**COA 17-87**

606 S 8th Street

Consideration of an approval for replacement of the existing metal shingle roof with 5V Crimp metal roof.

**HISTORIC PRESERVATION BOARD : PUBLIC HEARING**

Front façade

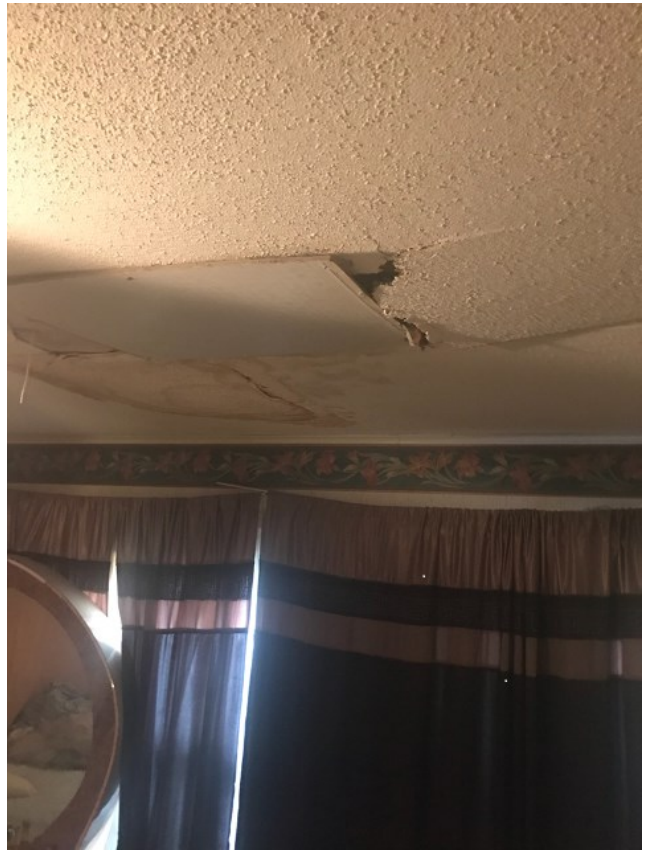
Identifying, retaining, and preserving roof materials are extremely important in defining a building's overall historic character. The replacement of the existing metal shingle roof with 5V Crimp metal roof alters the design and presents conflicts with the architectural and historical aesthetics of the structure. As stated in the Secretary of the Interior's Standards for Rehabilitation "Where the severity of deterioration requires replacement of a distinctive feature, the new feature will match the old in design, color, texture, and, where possible, materials".

The request to replace the existing metal shingle roof with 5V Crimp Metal Panels presents a conflict with Secretary of Interior Standards, therefore staff recommends that the Board deny the request or condition the request approval upon the utilization of metal shingles.
